ENCLOSURES:
Request for change to tech specs.....consist of Title changes within the station organization....and Changes to the Station organization chart, Fig. 6.1-1

PLANT NAME: Oconee

Re: Oconee Nuclear Station
Docket Nos. 50-269, -270, -287

OCONEE NUCLEAR STATION
STATION ORGANIZATION CHART
FIGURE 6.1-1

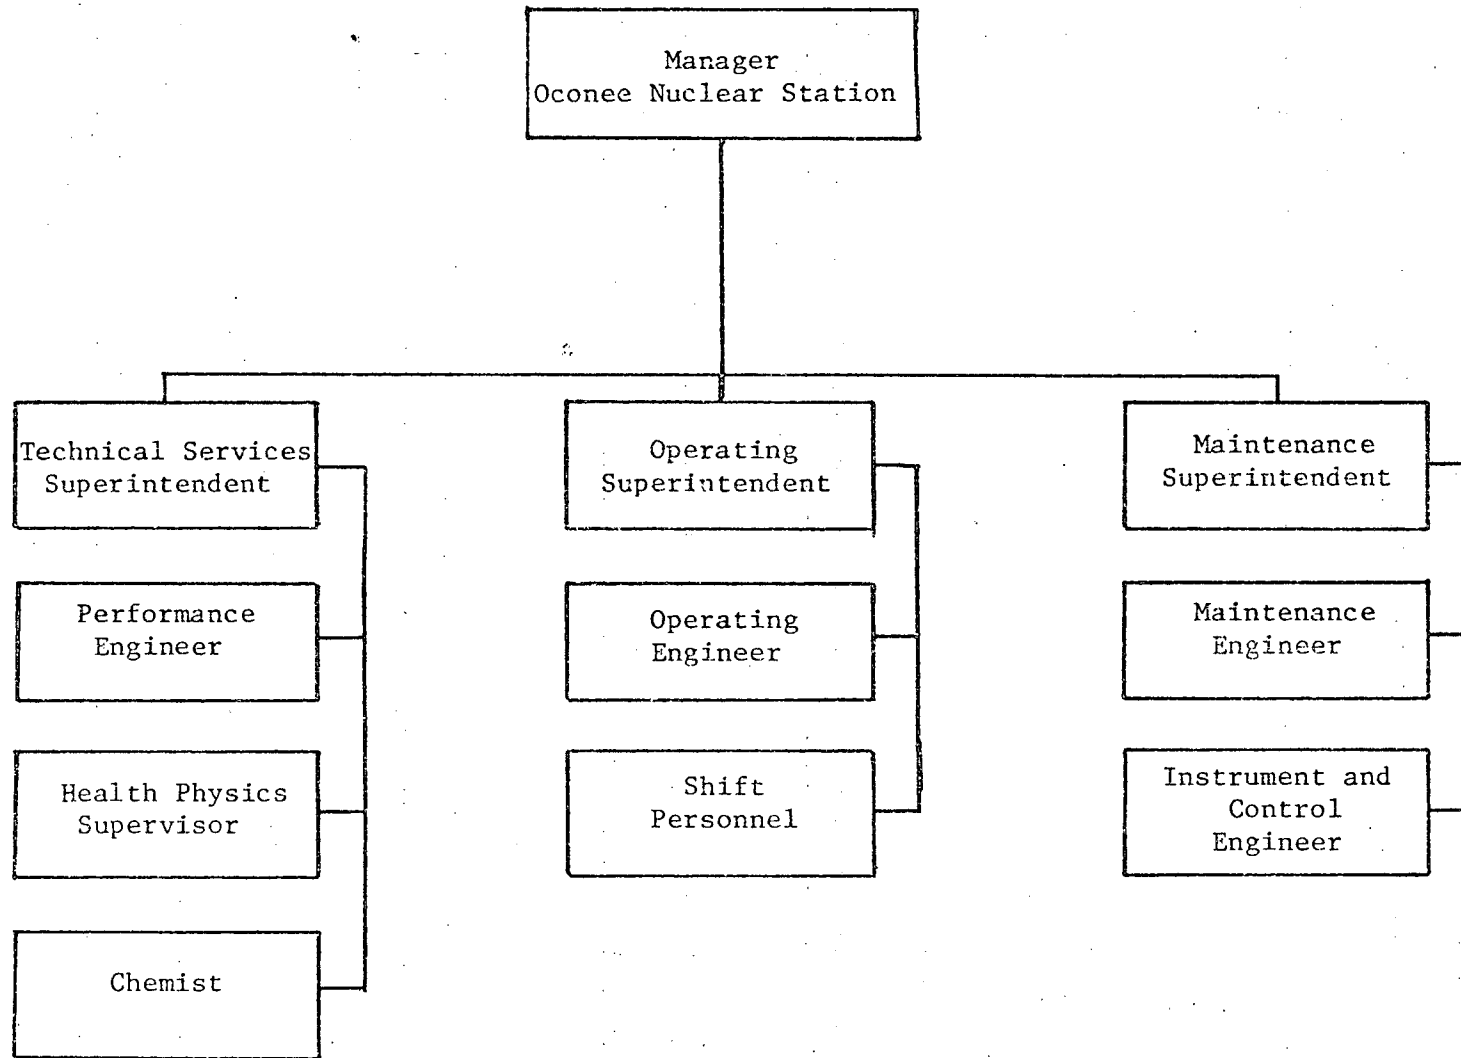
1. Title changes within the station organization such as Superintendent to Manager, Technical Support to Technical Services, etc.
2. Changes to the station organization chart, Figure 6.1-1.

6.1.1.3 The station organization for Operations, Technical Services, and Maintenance shall be functionally as shown in Figure 6.1-1. Minimum operating shift requirements are specified in Table 6.1-1.

OCONEE NUCLEAR STATION
 MANAGEMENT ORGANIZATION CHART
 FIGURE 6.1-2

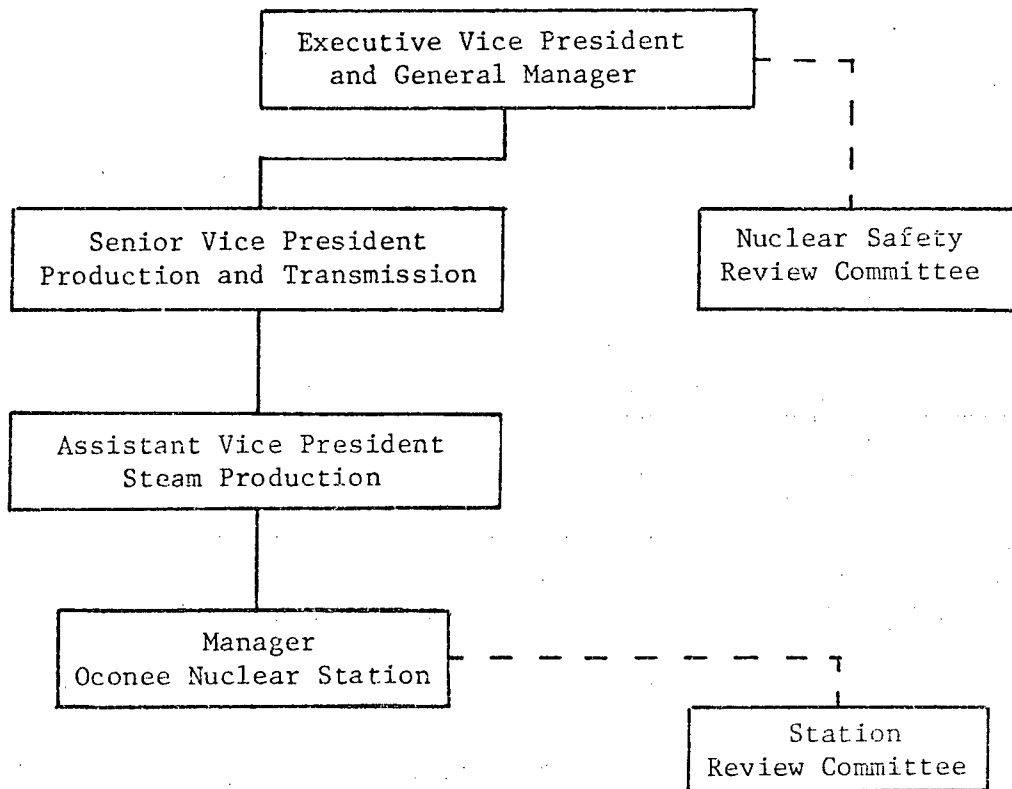
6.1.1.2 In all matters pertaining to actual operation and maintenance and to these Technical Specifications, the station Manager shall report to and be directly responsible to the Assistant Vice President, Steam Production. The organization is shown in Figure 6.1-2.

In matters of nuclear safety and radiation exposure, review and audit of station operation, maintenance, and technical matters shall be provided by two committees as follows: (Reference Figure 6.1-2)
